RE: DP-1717, Roca Honda Mine Southern Pipeline Alternative

Roca Honda Resources Response to New Mexico Environment Department 09-10-2014 Comments of Roca Honda Project Mine Discharge Plan-1717, Work Plan for Evaluation of the Potential Effects of Discharge Along the Rio San Jose dated August 2014

NMED Review of Roca Honda Resources Work Plan Evaluation of Discharge to Rio San Jose			
Reviewer: David L. Mayerson Agency: NMED		Review Date: September 10, 2014	
Item #	Section/Page (or general)	Quoted Text	Comment
1.	Page 4, Section 2, first paragraph	San Mateo Creek received discharge from various uranium mines in the past and there was concern about possible remobilization of contaminants from mine water discharge.	Since ephemeral surface flow in San Mateo Creek joins the Rio San Jose (RSJ) near the proposed discharge location, this study also should determine if similar concerns are warranted for the Rio San Jose.

Figure 2-1. Sediment and Well Point Location Map

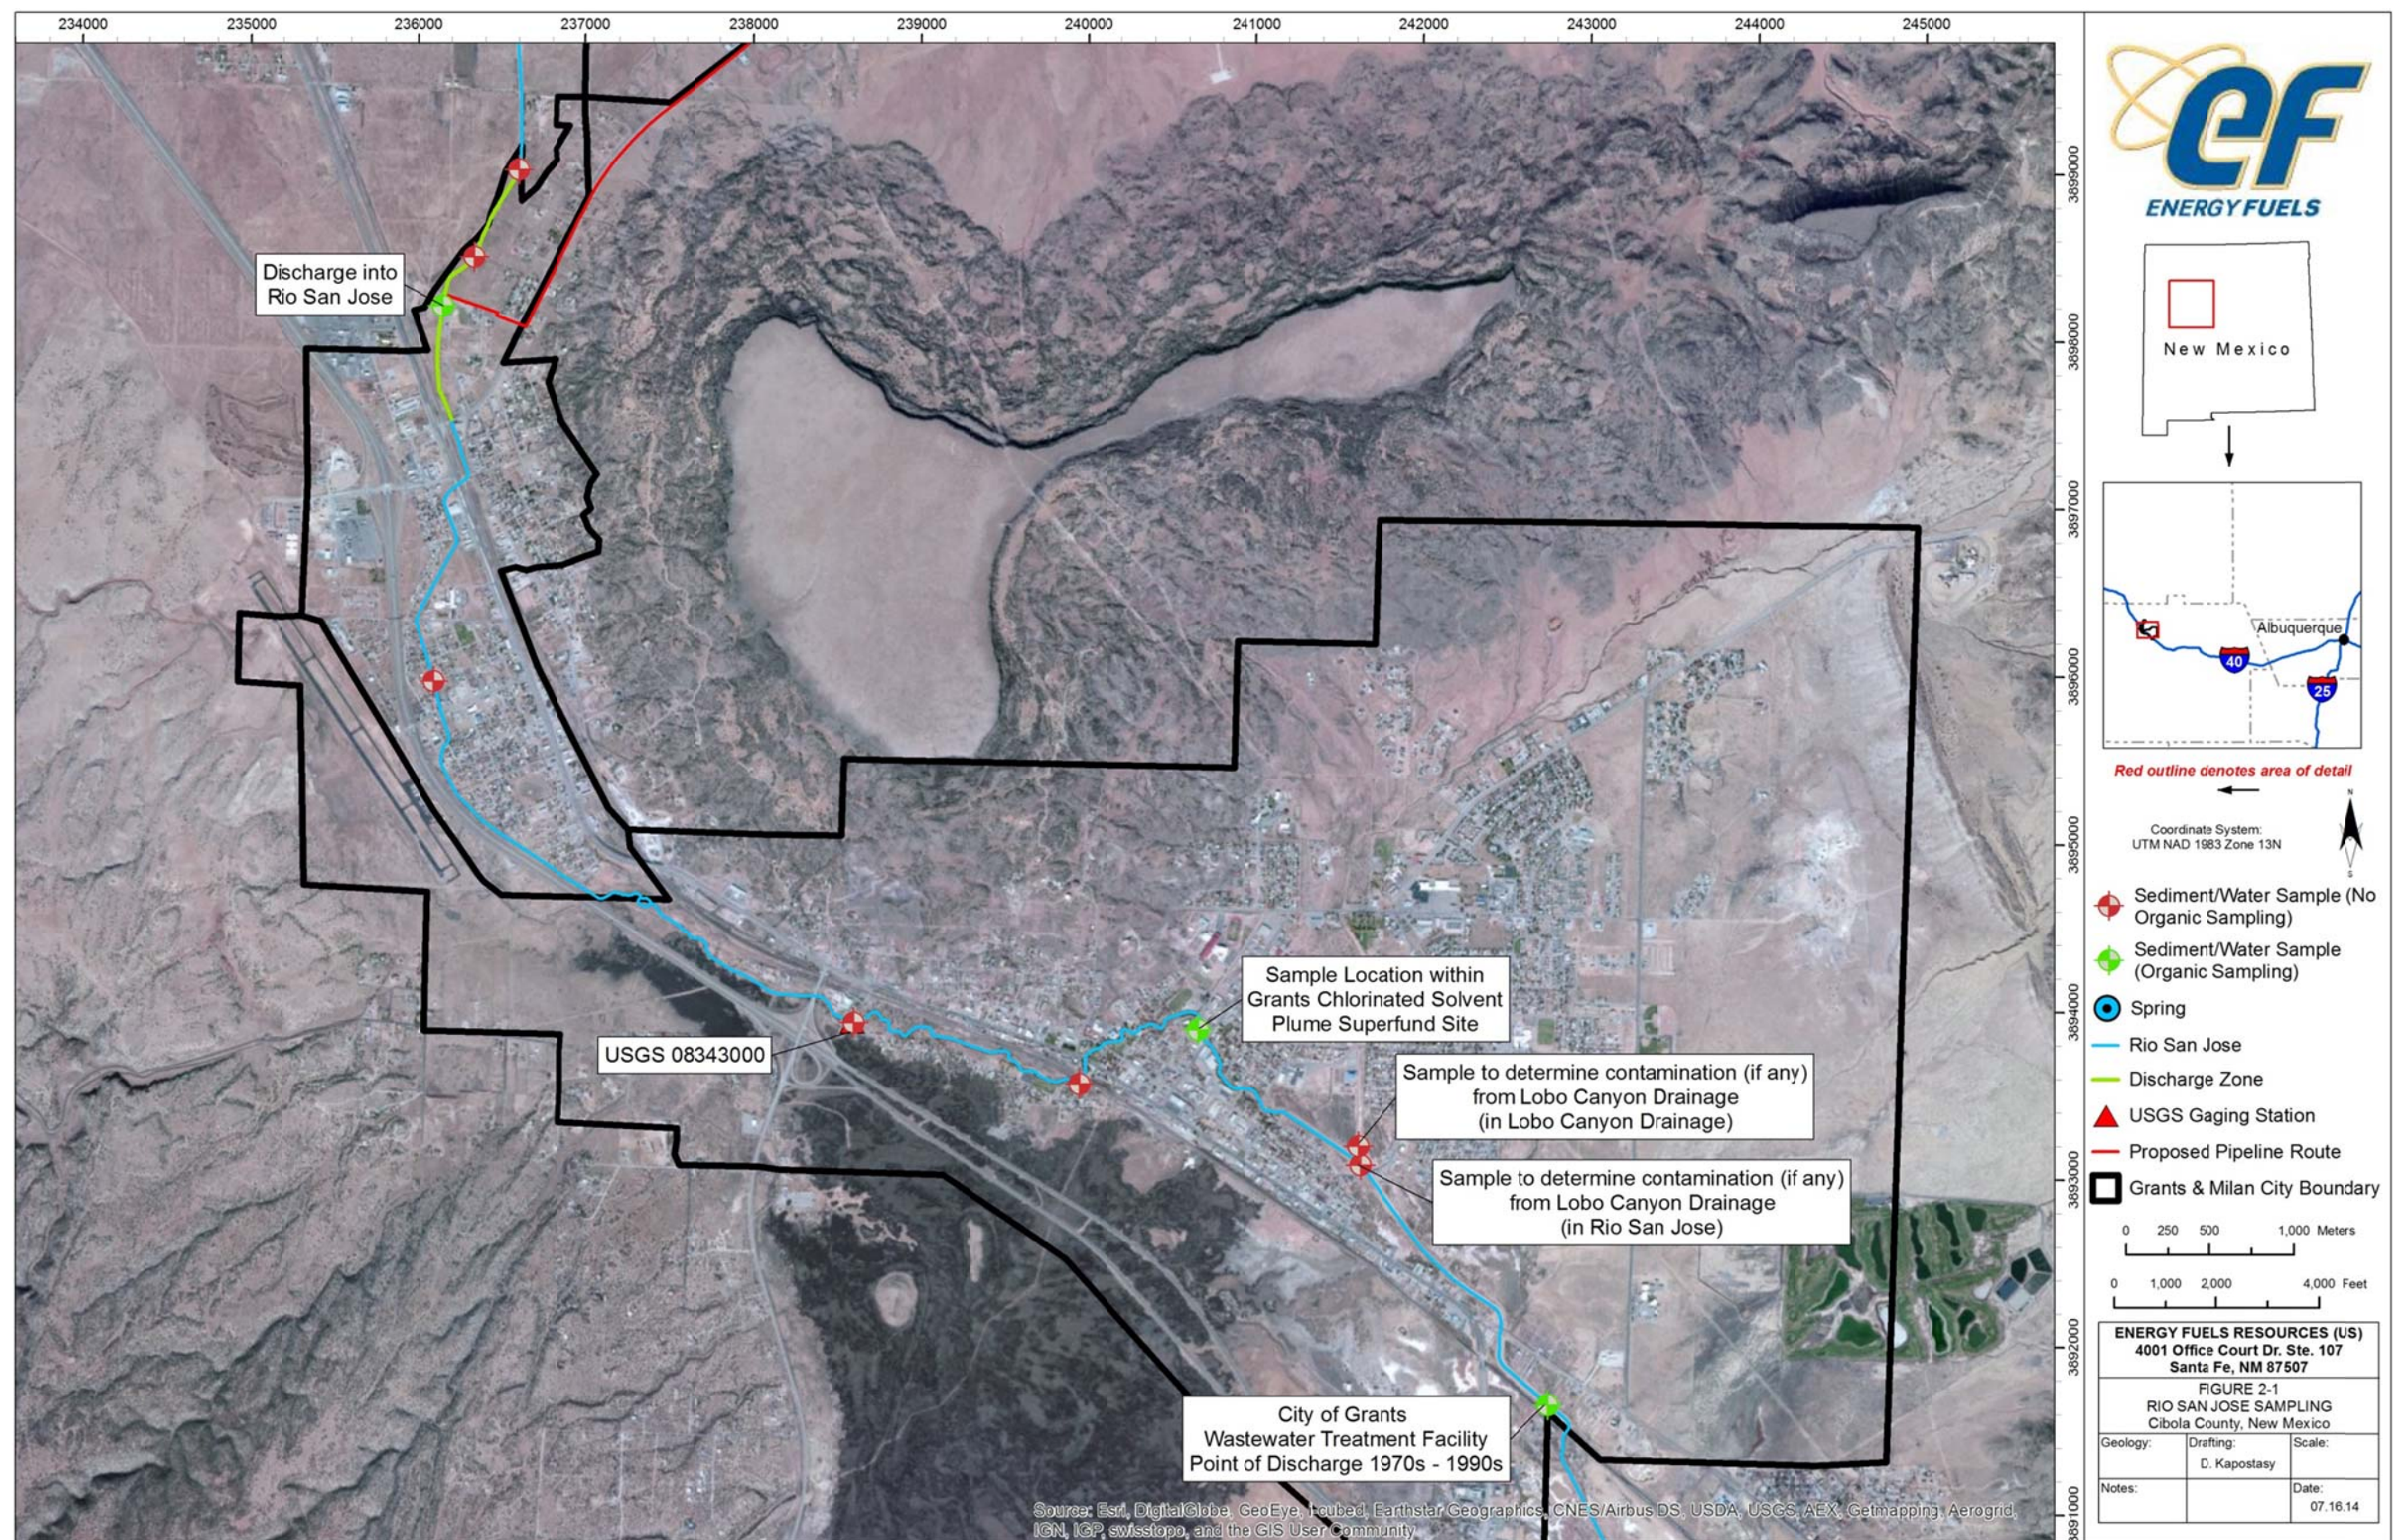
3.	Page 5, Section 2.1, Fifth paragraph	One of the sample locations is at the USGS gaging station 08343000 and another is at the former discharge location of the city of Grants wastewater treatment facility.	<p>Please identify these locations on Figure 2-1 (NMED acknowledges that the USGS gaging station location is shown on Figure 1-1).</p> <p>Please explain the rationale for the proposed two adjacent locations west of the “final sample location.”</p>
	RHR Response		<p>The USGS station and former WWTP discharge point will be labeled on Figure 2-1. (See Replacement Page)</p> <p>The two adjacent locations are now labeled on Figure 2-1. One of the samples is in a tributary to the RSJ draining Lobo Canyon. The purpose of this sample is described in the text to see what, if any, contamination is entering from this tributary. The sample next to it is a regularly spaced sample in the RSJ channel and if contamination is found in the tributary should show if that contamination is moving into the RSJ.</p>
